CONFIGURATION CHANGE

SHEET 1 of 2	EDM USE ONLY
	CC No. 4
	DATE 12-8-80

REQUESTED BY WESLEY TAM	<input type="checkbox"/> SPECIFICATION <input checked="" type="checkbox"/> DRAWING <input type="checkbox"/> PROCEDURE <input type="checkbox"/> INSTRUCTION	REVISION 3	CLASS SR
TITLE ELEM. DIAGRAM	NUMBER 64353	SUPPLIER	
CV MTR FEED CV-516 CV-526, CV-528 & CV-737B		<input type="checkbox"/> BECHTEL <input checked="" type="checkbox"/> EDISON	
DESCRIPTION OF CHANGE		I.O. NO. 7764	W.O. NO.

ELEMENTARY DIAGRAM
CV MTR FEED - CV-516,
CV-526, CV-528 & CV-737B

AFTER
 Drwg. # 64353-3
 CC # 4
 Sheet # 2 of 2

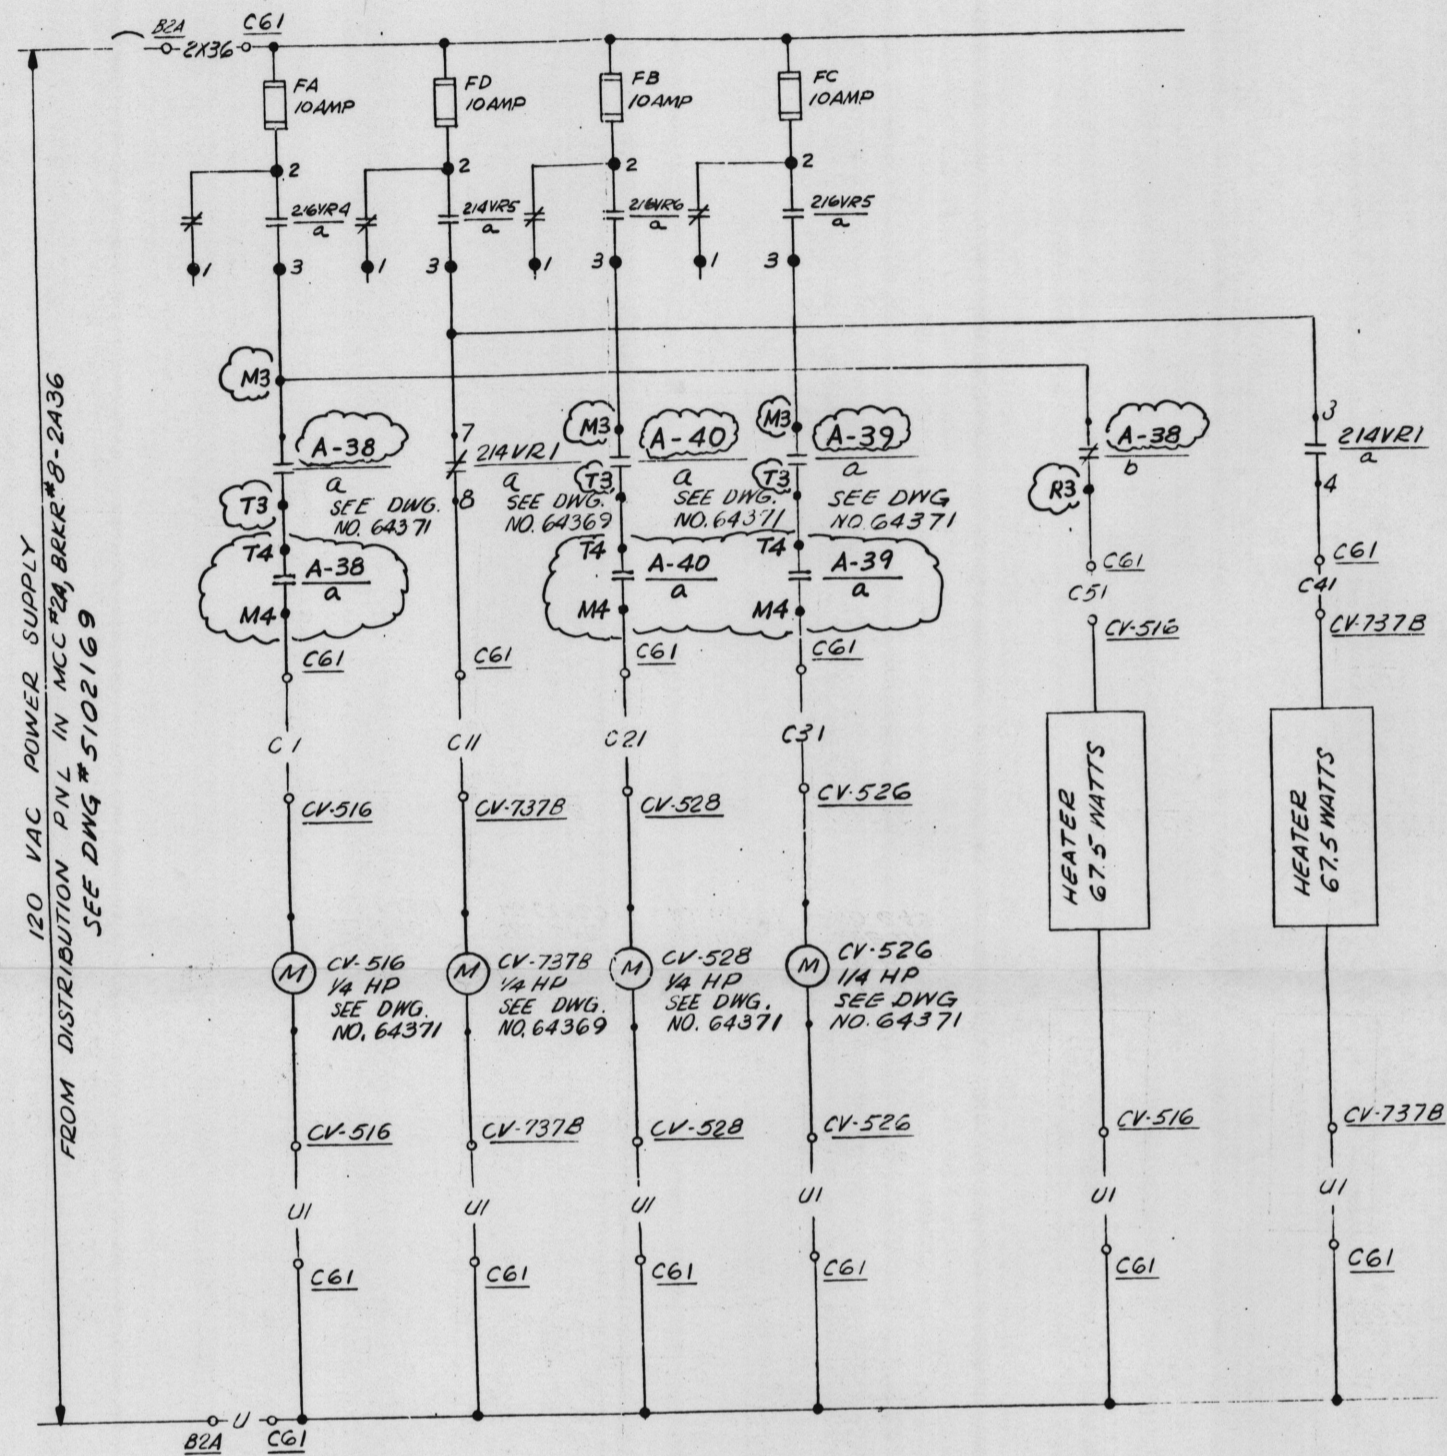
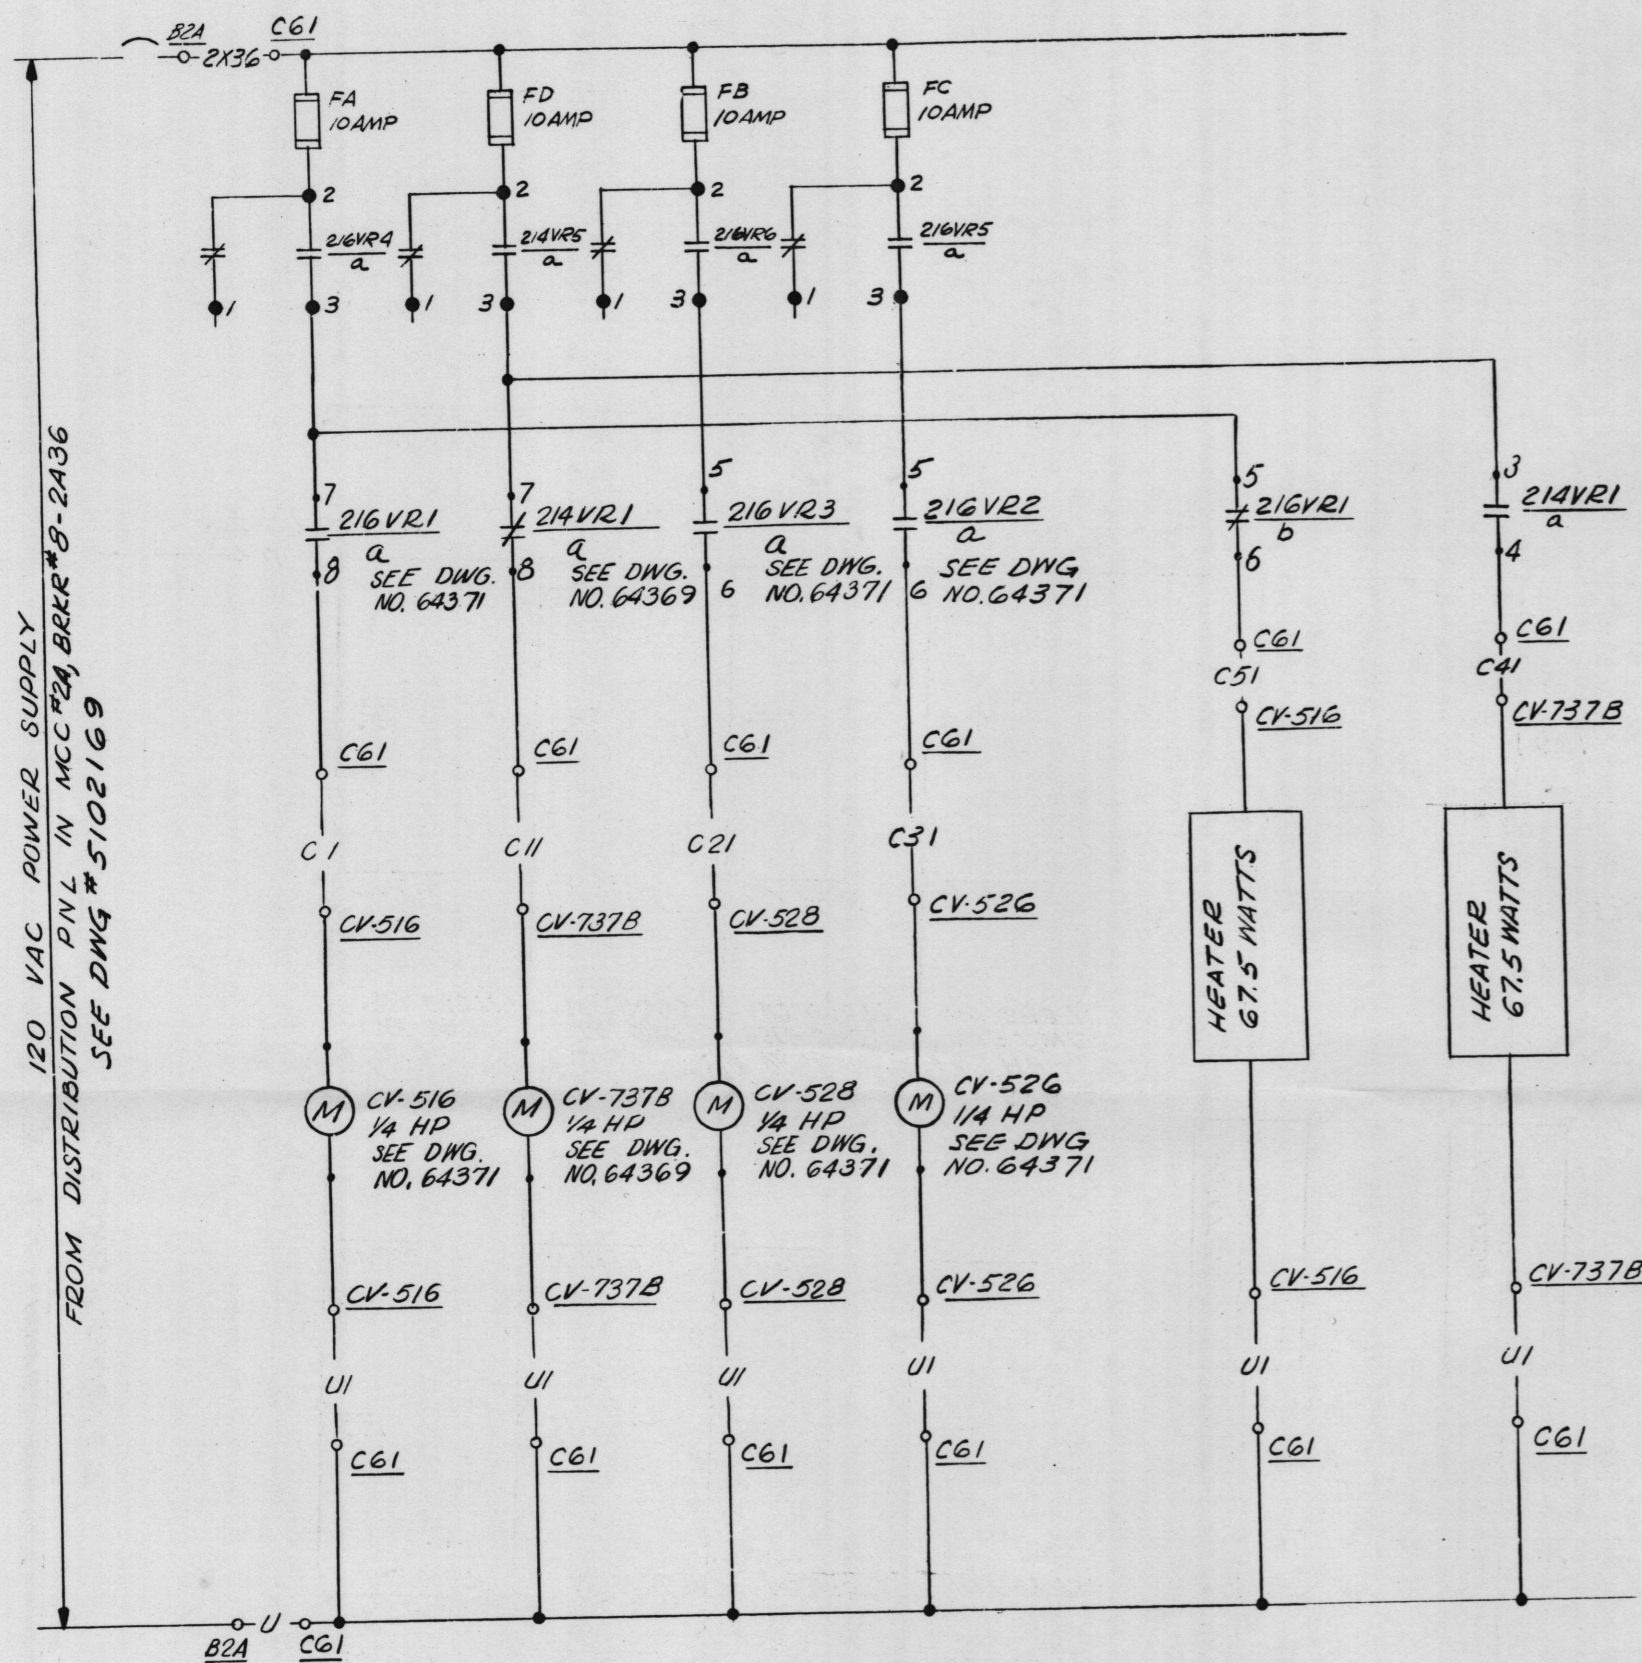
- CHANGE RELAY CONTACTS AND TERMINAL NUMBERS:
FROM TO

216VR1 (7-8)	A-38 (M3-T3) & A-38 (M4-T4)
216VR3 (5-6)	A-40 (M3-T3) & A-40 (M4-T4)
216VR2 (5-6)	A-39 (M3-T3) & A-39 (M4-T4)
216VR1 (5-6)	A-38 (M3-R3)
- ADD WORK PACKAGE NUMBER AND REMOVE THE TERM "NUCLEAR" FROM SAFETY RELATED CLASSIFICATION.

JUSTIFICATION
 REPLACE HFA RELAYS WITH QUALIFIED IE AGASTAT RELAYS FOR CONTAINMENT ISOLATION VALVES CV-516, CV-526 & CV-528.
 TMI-II W.P. #2.1.4
